Device info

General Info (Copied and pasted):

Figure 16. DRV8323xEVM Gate Signal

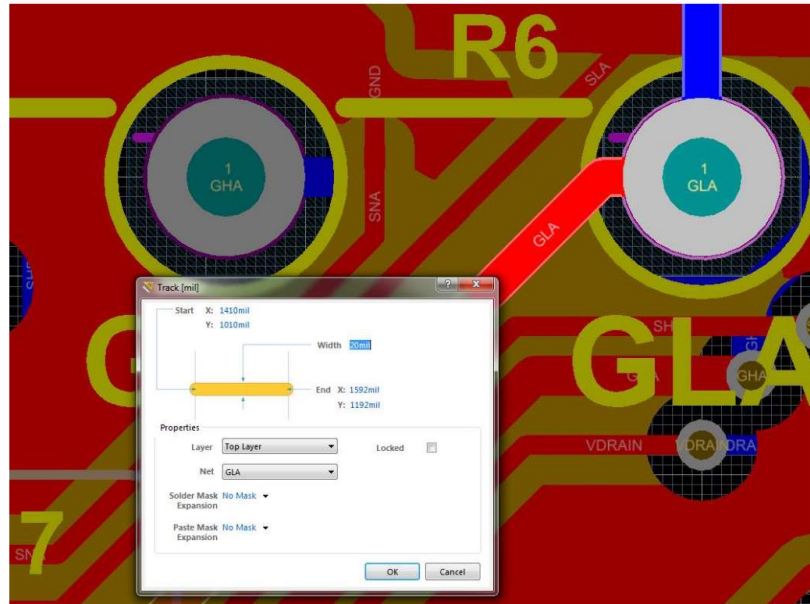
- Your traces don't look like 20 mils on your gate driver and FET paths

- See some points you did do this

- Make gate drive traces wide and as short in length as possible. Start with a trace width of 20 mils for at least a 1 oz copper, more if required by high currents.

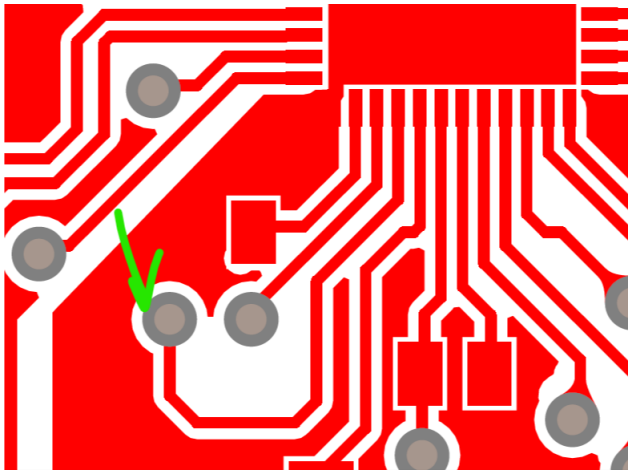
- In context of info above, it looks like INx signals were given priority to other signals
 - For example, DVDD, the decoupling caps, and the GND return path to the GND pin could have been make more optimal if INx thrown into vias or routed more directly to the connector
 - Recheck every cap to make sure its optimal and prioritized

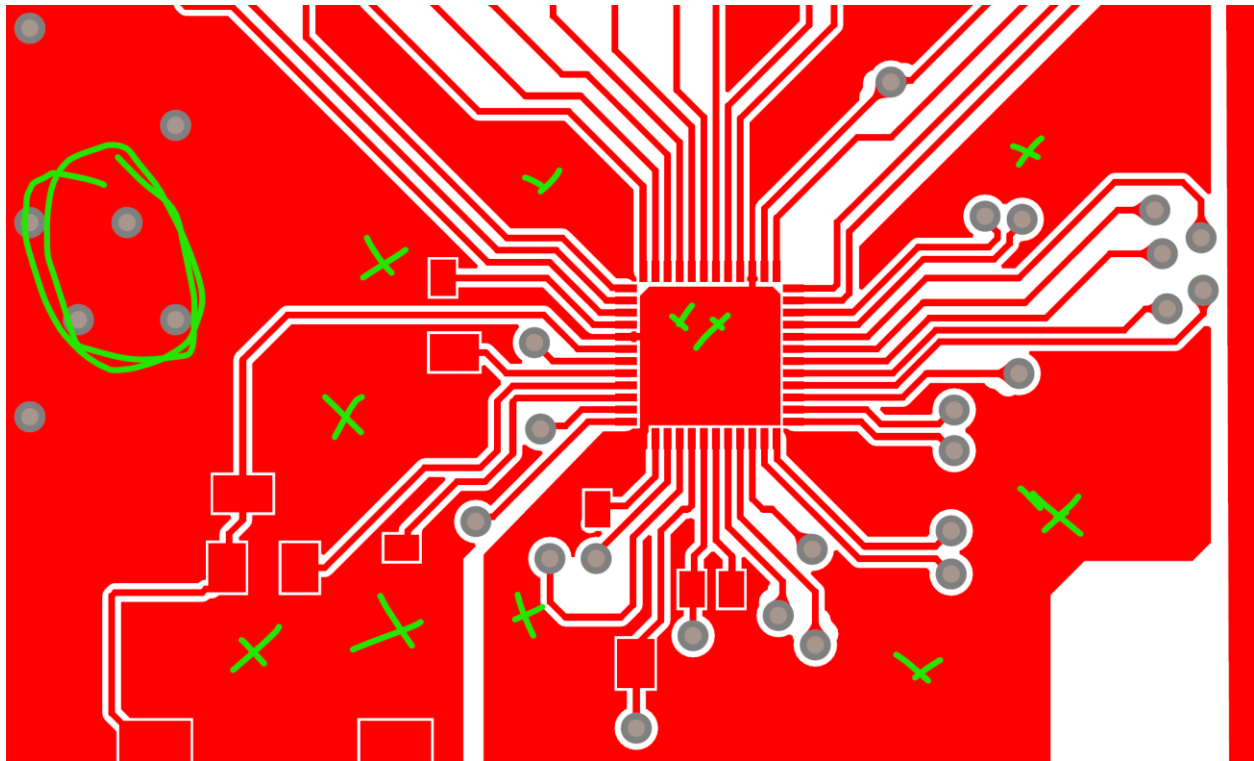
- In context of above, CPL and CPH were not given priority and routed through vias

- I might have the wrong layers here but it looks like the circle is contained with vias which means there's no GND stitching vias close to the device (or even under the power pad).

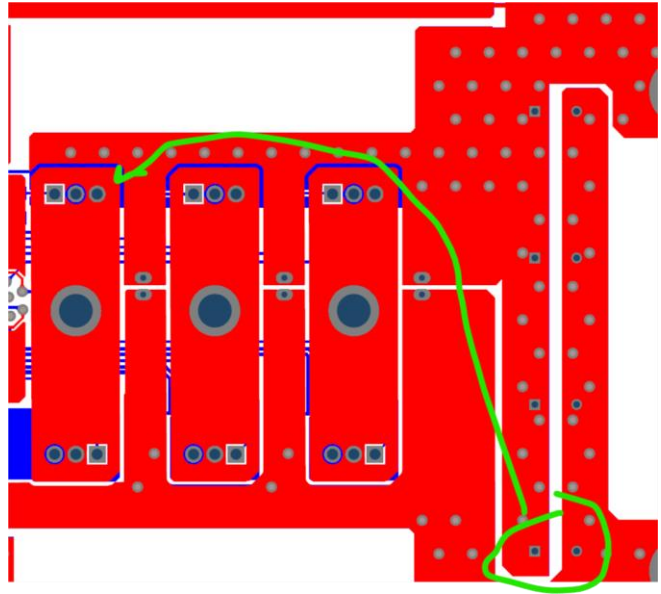
- Look at difference between recommend bulk caps compared to yours

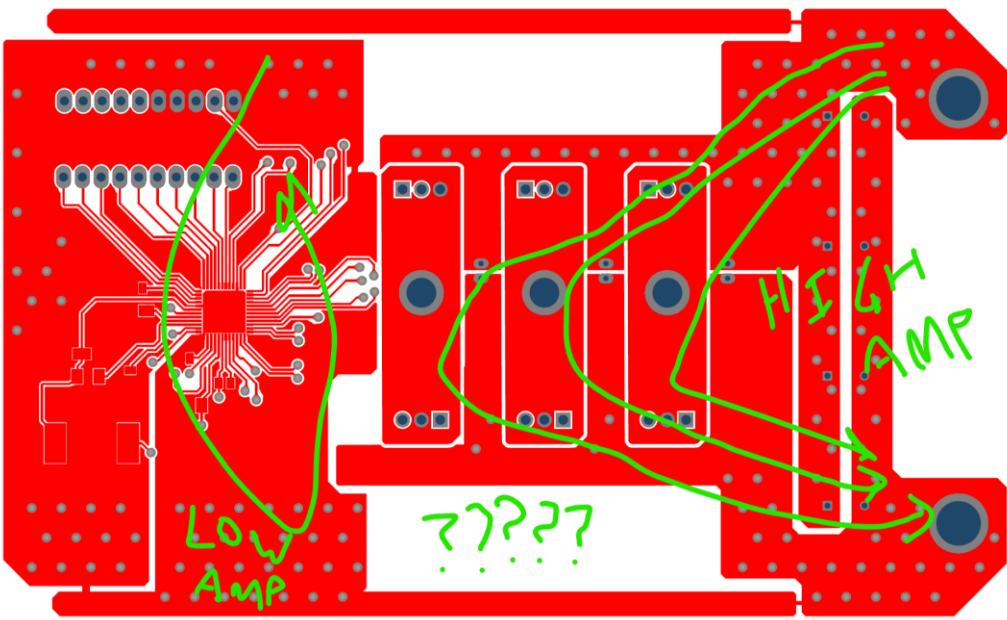
- Doing this layout makes L_{source} and L_{drain} pretty large. See how recommended layout does not put the phase in the switching path?
 - The TI Design I liked does do this, but the FETs are much closer together. You might want to consider tightening up the FETs

- Common Ground is always the better layout technique. Split GND is only needed when high current is expected to flow near the DRV. If high current will never travel near, then the inductance created the objectively worse layout compared to the split GND provides no benefits.
 - Also, fill in GND in the empty spaces on both layers. There's no reason not to.

Figure 32. Gate Driver Block Diagram

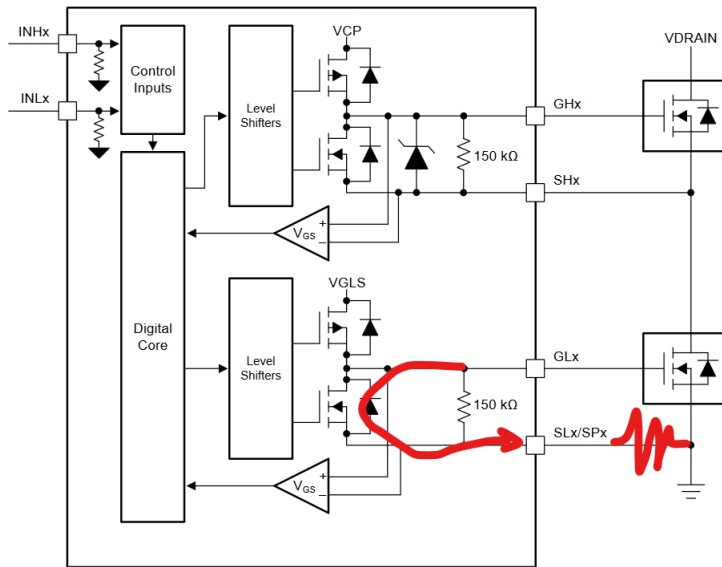
- I think you have resistors in the sense path? Maybe? I don't have a schematic to tell. But if there are resistors in the SPx path you'll add inductance in the path so its not recommended to do filtering on the input of the CSA but do it on the output instead.
